ISSUE 1: CHUTE GATE: IT WAS FOUND THAT OPERATION OF THE CURRENT 24 X 36" CHUTE GATES IS INADEQUATE. UNDER FULL LOAD AS THE CHUTE DOORS REQUIRE EXCESSIVE FORCE TO OPEN. THIS FIELD SERVICE BULLETIN DETAILS THE REPLACEMENT OF THE CURRENT CHUTE GATE SYSTEM WITH A NEW BOLTED TOGETHER DESIGN WITH ROLLER WHEELS AND RACK AND PINION DRIVE DOORS.

PRESTIGE
BOX 1146 WINKLER MANITOBA CANADA R6W 4B2

DWG. NO. FS201801

OLD CHUTE GATE REMOVAL

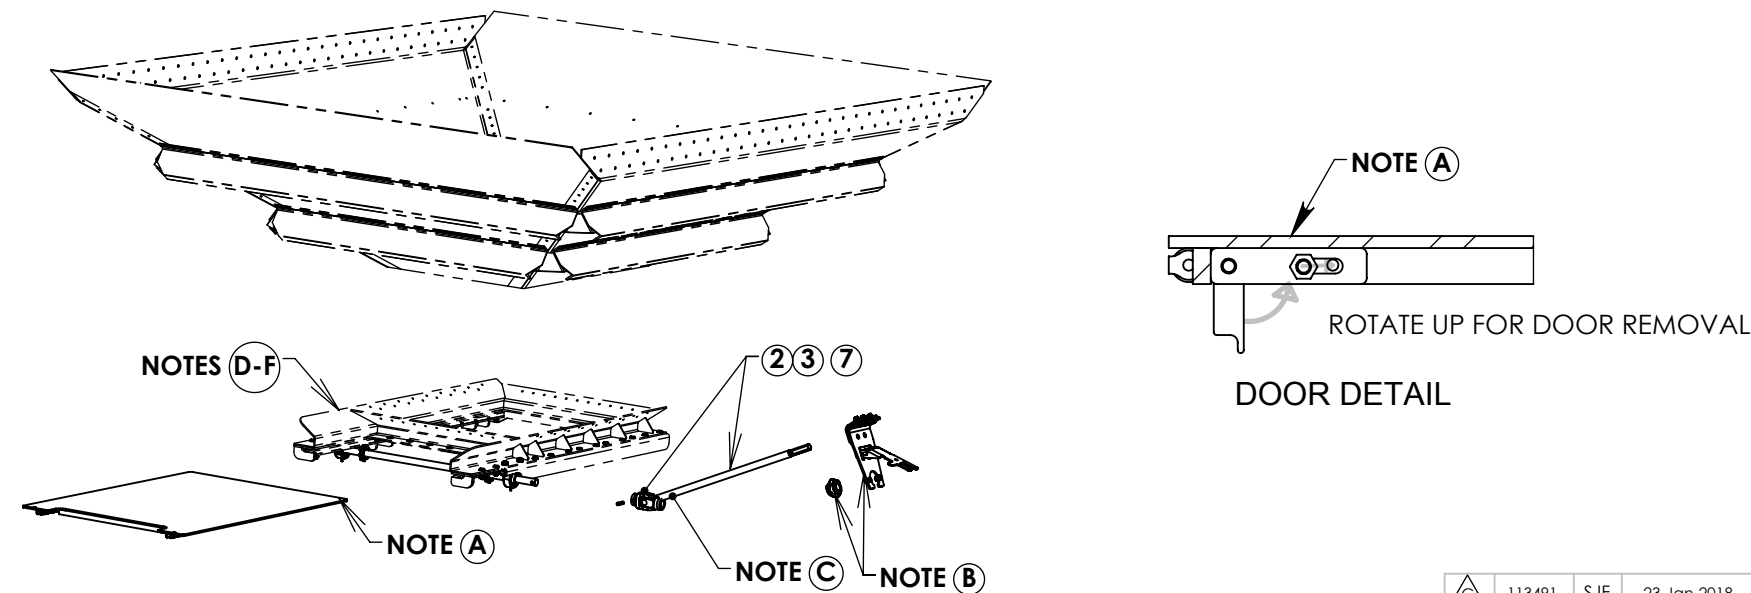
ISSUE 2: CRANK LOCK: IT WAS FOUND THAT THE CURRENT CRANK LOCK ASSEMBLY WITH A 96W TRAILER AND LARGE CHUTE GATES PREVENTS THE OPERATOR FROM INSTALLING THE CRANK ONTO THE CRANK SHAFT WHEN IN THE LOCKED POSTION. THE CURRENT LOCKING PLATE IS TOO LONG AND EXTENDS TO THE END OF THE CRANK SHAFT, THEREFORE PREVENTING THE OPERATOR FROM INSTALLING THE CRANK ON THE SHAFT. THIS FIELD SERVICE BULLETIN DETAILS THE REPLACEMENT OF THE CURRENT LOCK ASSY WITH A SHORTER LOCK ASSY.

- A. LOCK DOOR CATCH IN UPWARD POSITION AND REMOVE CHUTE DOOR FROM HOPPER AND DISCARD.
- B. REMOVE CRANK LOCK ASSEMBLY AND UPPER CRANK SHAFT BEARING FROM HOPPER AND DISCARD.

- C. REMOVE UPPER CRANK SHAFT AND U-JOINT ASSEMBLY FROM CHUTE GATE ASSEMBLY (**SPRING PINS (2) AND U-JOINT (7) WILL BE REUSED**)
- D. SUPPORT CENTER OF REMAINING CHUTE GATE FRAME WITH FLOOR JACK.

- E. CUT OFF ALL HUCKBOLTS HOLDING CHUTE FRAME TO BOTTOM OF HOPPER.
- F. LOWER FLOOR JACK AND DISCARD OLD CHUTE FRAME COMPONENTS.
- G. PLACE NEW CHUTE GATE ASSEMBLY (1) (**WITH DOORS AND DEFLECTOR SHEETS INSTALLED**) CENTERED ON FLOOR JACK AND LIFT INTO PLACE ON BOTTOM SIDE OF HOPPER. (NOTE ORIENTATION. DOOR OPENING TO CENTER OF TRAILER)

NEW CHUTE GATE INSTALL

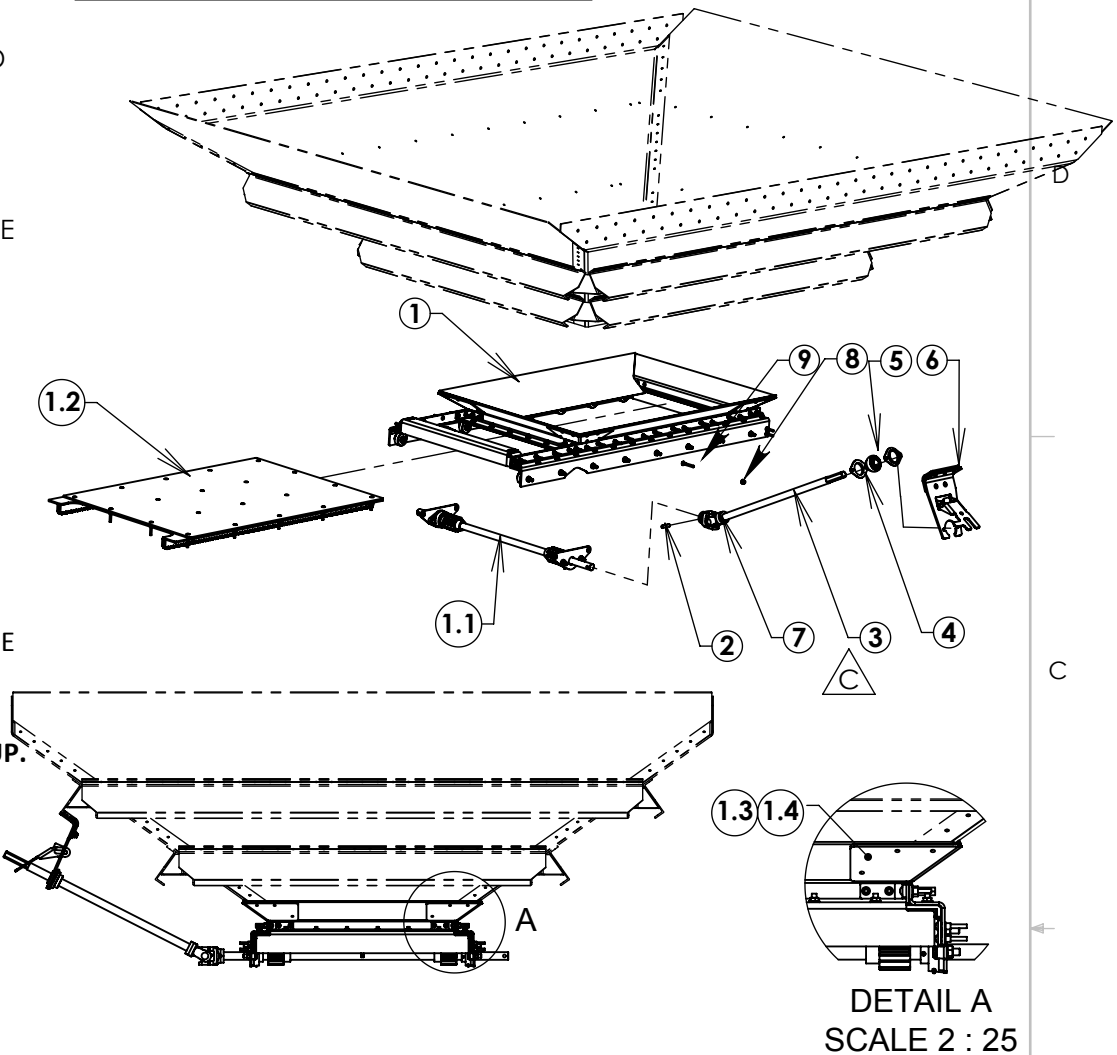
CRANK DRIVE ROD WAS 11AK0361 NOW 11AK0317

- H. **MATCH DRILL FROM INSIDE HOPPER THE CENTER 4 HOLES ON ALL FOUR SIDES** OF THE HOPPER USING PREVIOUS HUCK BOLT HOLES AND RECONNECT WITH SUPPLIED HUCK BOLTS(8-9). **NOTE: ALL HUCKBOLTS ARE INSTALLED WITH BOLT HEAD INSIDE HOPPER AND COLLAR TO OUTSIDE TO PREVENT GRAIN HANG UP.**

- I. INSTALL CORNER WRAPS(1.3 - 1.4) - **MATCH DRILLING THROUGH CORNER WRAPS** THROUGH GATE ASSEMBLY AND HOPPER AND HUCK BOLT TOGETHER.
- J. REMOVE FLOOR JACK AND CHUTE DOOR (4) FOR EASIER HUCKBOLT INSTALLATION.

- K. **MATCH DRILL REMAINING HOLES FROM HOPPER** INTO CHUTE FRAME AND HUCK BOLT ALL CONNECTIONS.
- L. CONNECT ORIGINAL U-JOINT ASSEMBLY (7) AND UPPER CRANK SHAFT TO NEW LOWER GEAR SHAFT (1.1) REUSING PREVIOUS SPRING PIN (2).

- M. INSTALL NEW CRANK LOCK (6) REUSING EXISTING HOLES AND HARDWARE.
- N. INSTALL NEW UPPER CRANK SHAFT BEARING (5) AND FLANGES(4).
- O. REINSTALL DOOR (1.2).

- P. TIME GEAR DRIVE AND LOCKING MECHANISM SO GATE IS FULLY CLOSED AND LOCK LINES UP WITH FLATS ON THE UPPER CRANK SHAFT.
